December 2008
Fuji Electric Systems Co., Ltd.
Controller Div.
Automation & Solution Business
Headquarters

MICREX-SX Series Notice of SPB Functional Expansion

We would like to thank you for your continued patronage of Fuji Programmable Controllers.
Please be informed that Fuji Electric Systems has expanded a function in the MICREX-SX-series SPB (SX mode) with a firmware upgrade.

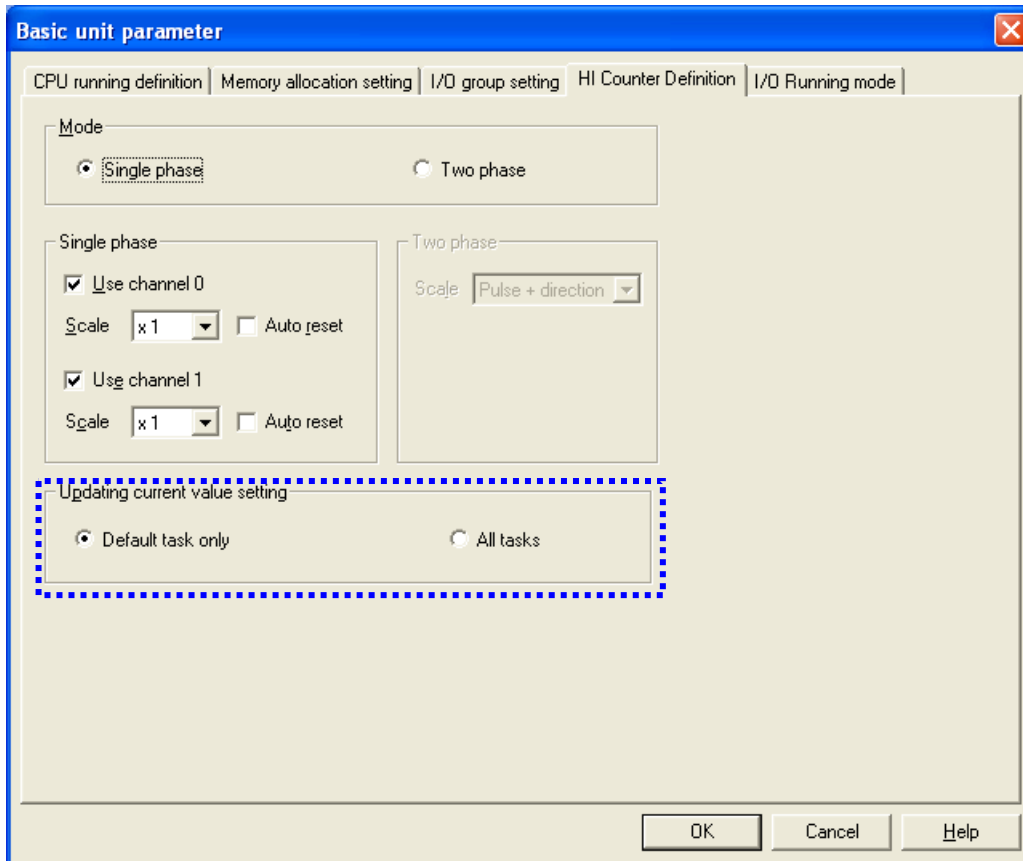
3. Functional Expansion

With the new version, it is possible to update the current value of a high-speed counter in synchronization with a scheduled task or event task.

Conventionally, the current value of a high-speed counter was updated in synchronization with the execution of the default tasks, which involved a maximum execution time delay equivalent to the execution cycle of the default tasks.

With this expansion, the current value can be updated in synchronization with the execution of an individual task. Therefore, the execution time delay of the current value read in each task will be limited to a maximum period of the task execution time.

The updating of current value setting is by default set to *Default task only* to maintain compatibility with the previous version of the Board Controller.
